## Design Review Subcommittee (DRSC)

Meeting Date: May 23, 2018

**SUBJECT:** **Discretionary Sign Permit 17-399, El Camino Real Shell Master Sign Program,** a request to consider a Master Sign Program for an existing service station located at 2400 South El Camino Real.

**Image 1 – Spanner Sign**

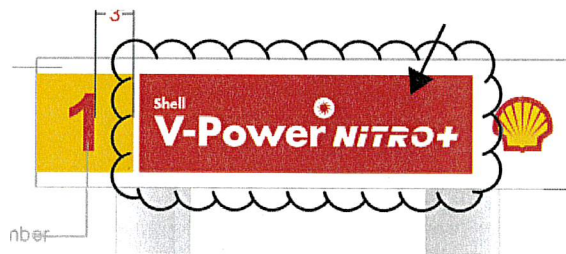
3. Remove the red background identified on Image 1 below from the spanner signs, and use red font for "Shell V-Power Nitro" instead. Since white is a prominent color of Spanish architecture, this will improve architectural compatibility.
